Amendments to the Drawings:

The attached sheet of drawings includes changes to Figs. 1, 5C, 8, 11 and 13. The attached sheets replace the original sheets that included Figs. 1, 5A-5C, 8, 11 and 13.

FIG. 13

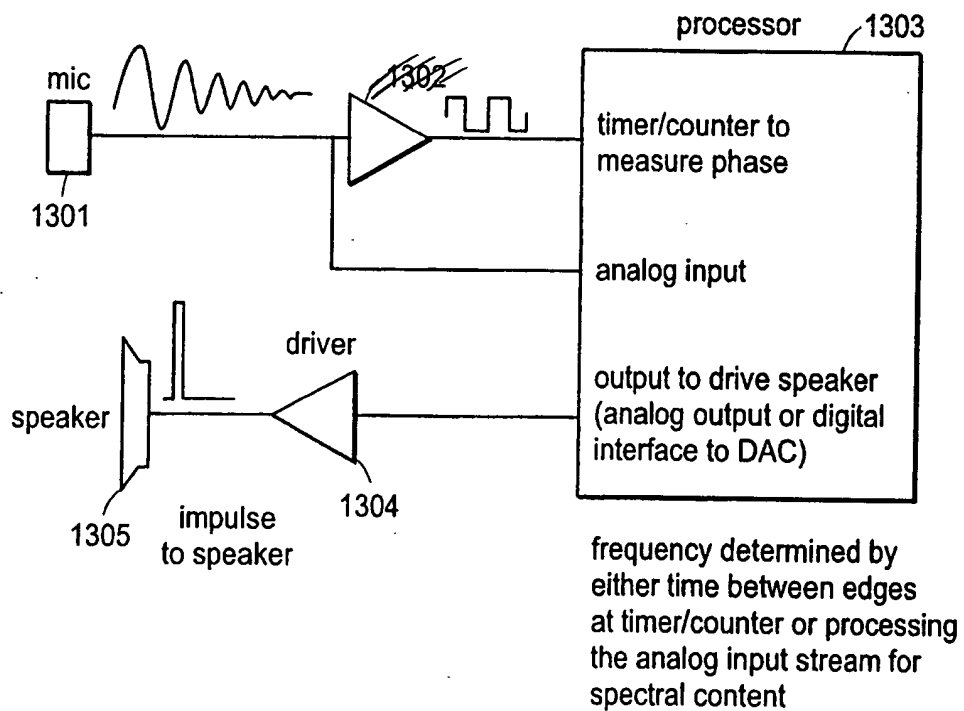
In Fig. 13, superfluous label 1302 has been removed.

FIG. 1

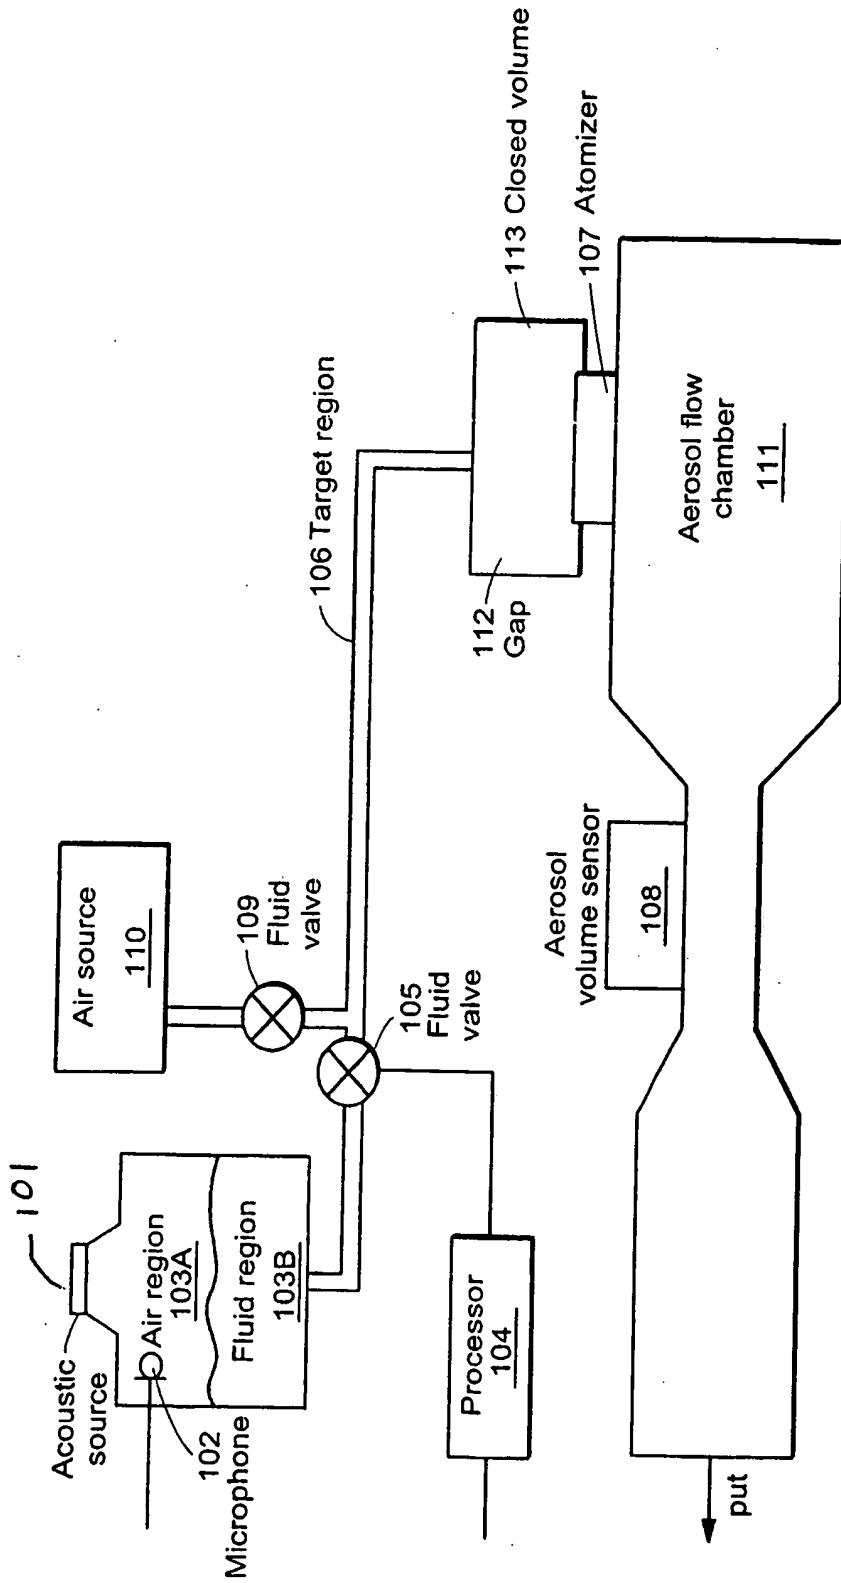
In Fig. 1, the acoustic source **101** has been labeled, per the text.

FIG. 5C

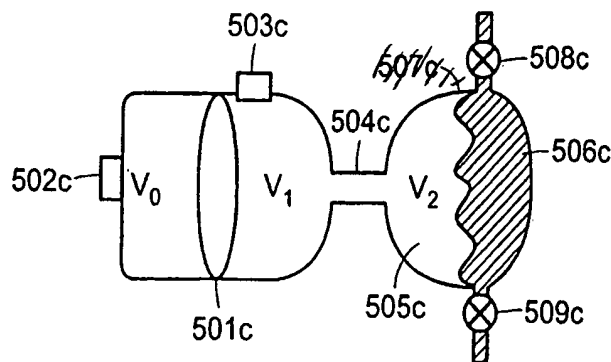
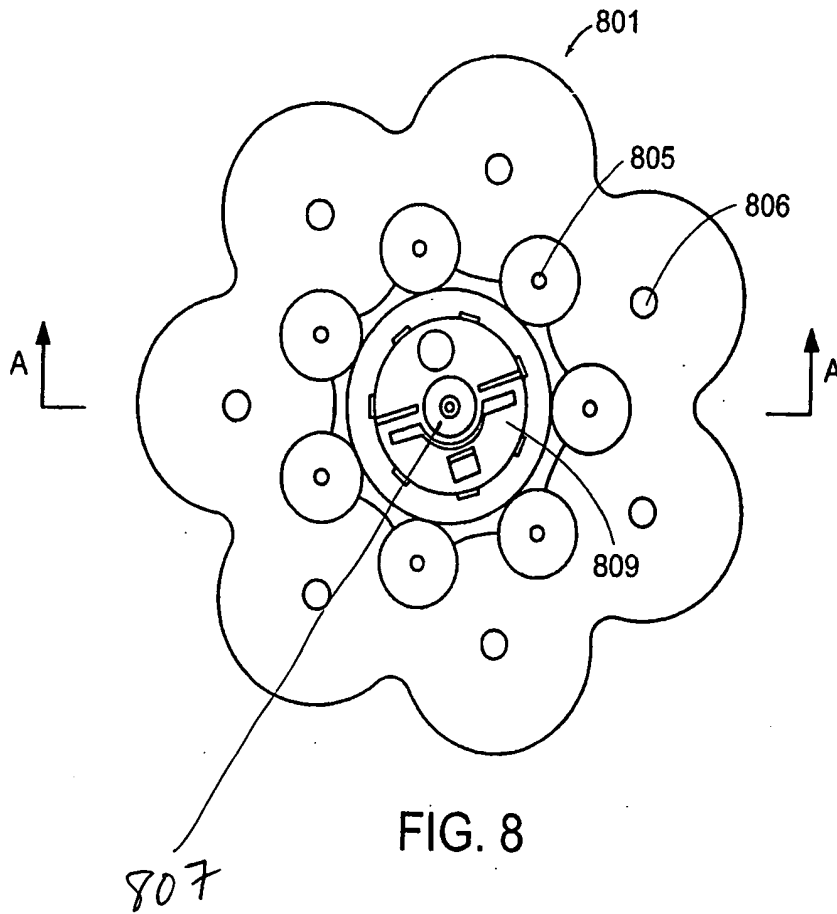
In Fig. 5C, superfluous label 507c has been removed.

FIG. 11

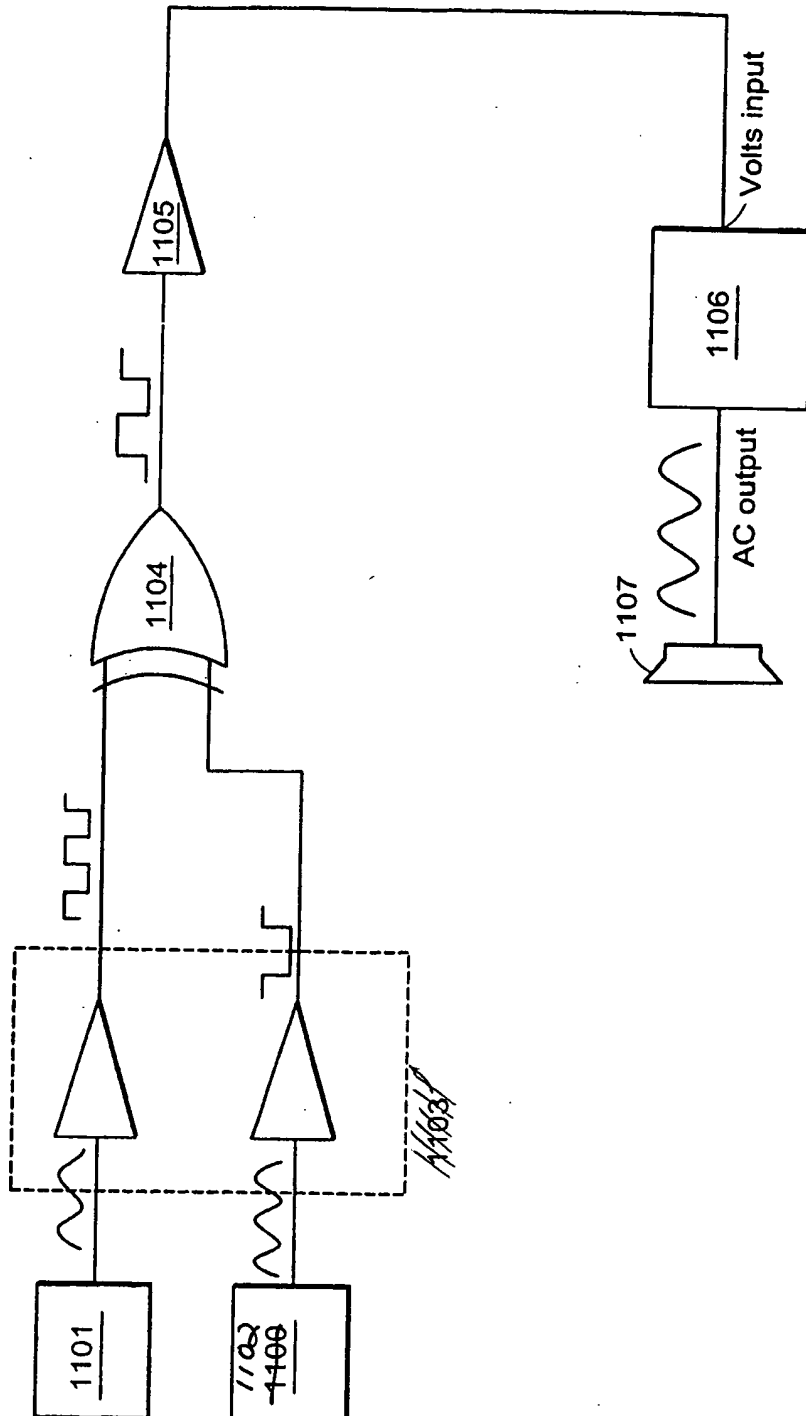
In Fig. 11, reference number **1102** is now correctly presented, and superfluous label 1103 has been removed.
